Division of Health Service Regulation

STATEMENT OF DEFICIENCIES AND PLAN OF CORRECTION		(X1) PROVIDER/SUPPLIER/CLIA IDENTIFICATION NUMBER: FCL092138	(X2) MULTIPLE CONSTRUCTION A. BUILDING: 01 B. WING _____	(X3) DATE SURVEY COMPLETED 03/30/2017
NAME OF PROVIDER OR SUPPLIER AVENDELLE ASSISTED LIVING AT WYCKFORI		STREET ADDRESS, CITY, STATE, ZIP CODE 4520 DILFORD DRIVE RALEIGH, NC 27604		
(X4) ID PREFIX TAG	SUMMARY STATEMENT OF DEFICIENCIES (EACH DEFICIENCY MUST BE PRECEDED BY FULL REGULATORY OR LSC IDENTIFYING INFORMATION)	ID PREFIX TAG	PROVIDER'S PLAN OF CORRECTION (EACH CORRECTIVE ACTION SHOULD BE CROSS-REFERENCED TO THE APPROPRIATE DEFICIENCY)	(X5) COMPLETE DATE
C 000	Initial Comments Report by Glenn Hoppin DHSR Construction Section conducted a Biennial Survey on March 30, 2017 from 12:30 PM to 2:30 PM at the above referenced facility. DHSR records indicate the home was first licensed on June 05, 2008 as a Family Care Home for six ambulatory Residents (able to evacuate and respond without any physical or verbal assistance during a fire or other emergency.) On January 01, 2014 the facility was licensed for six non-ambulatory residents (unable to evacuate and respond without any ph

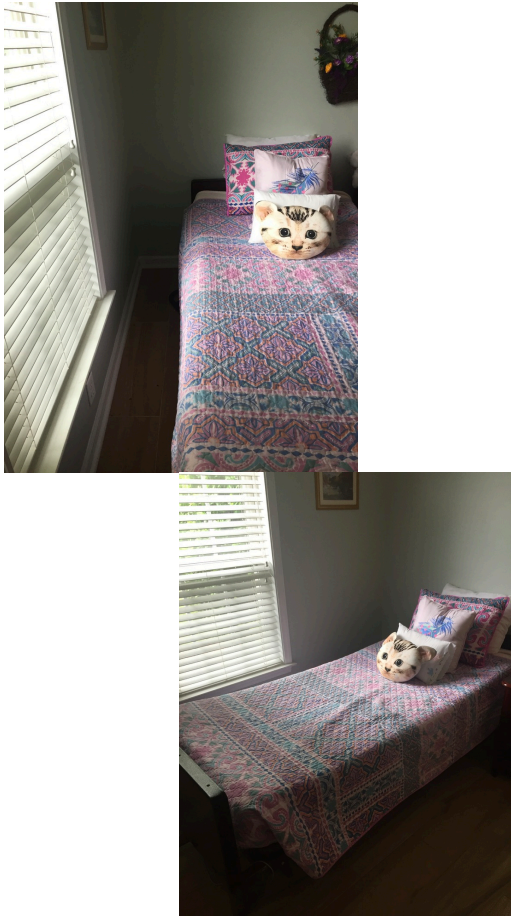
C 174	Building Equipment Maintained Safe, Operating SECTION .0300 - THE BUILDING 10A NCAC 13G .0317 BUILDING SERVICE EQUIPMENT (a) The building and all fire safety, electrical, mechanical, and plumbing equipment in a family care home shall be maintained in a safe and operating condition. (j) This Rule shall apply to new and existing family care homes. This Rule is not met as evidenced by: Observations revealed that the building is not	C 174

STATEMENT OF DEFICIENCIES AND PLAN OF CORRECTION		(X1) PROVIDER/SUPPLIER/CLIA IDENTIFICATION NUMBER: FCL092138	(X2) MULTIPLE CONSTRUCTION A. BUILDING: 01 B. WING _____	(X3) DATE SURVEY COMPLETED 03/30/2017
NAME OF PROVIDER OR SUPPLIER AVENDELLE ASSISTED LIVING AT WYCKFORI		STREET ADDRESS, CITY, STATE, ZIP CODE 4520 DILFORD DRIVE RALEIGH, NC 27604		
(X4) ID PREFIX TAG	SUMMARY STATEMENT OF DEFICIENCIES (EACH DEFICIENCY MUST BE PRECEDED BY FULL REGULATORY OR LSC IDENTIFYING INFORMATION)	ID PREFIX TAG	PROVIDER'S PLAN OF CORRECTION (EACH CORRECTIVE ACTION SHOULD BE CROSS-REFERENCED TO THE APPROPRIATE DEFICIENCY)	(X5) COMPLETE DATE
C 174	Continued From page 1 being maintained in a safe and operating condition. Findings: There is furniture blocking the window in the front right bedroom. One window in every bedroom must be accessible for emergency egress in the event of a fire or emergency. Move the furniture so that the window is accessible for emergency egress. Provide photo documentation to the DHSR Construction Section when this item is completed.	C 174	The bed blocking the window has been moved. Additionally, the bed is on wheels, so in the case of an emergency, the bed can easily be moved further if needed. See attached pictures. 	04/20/17
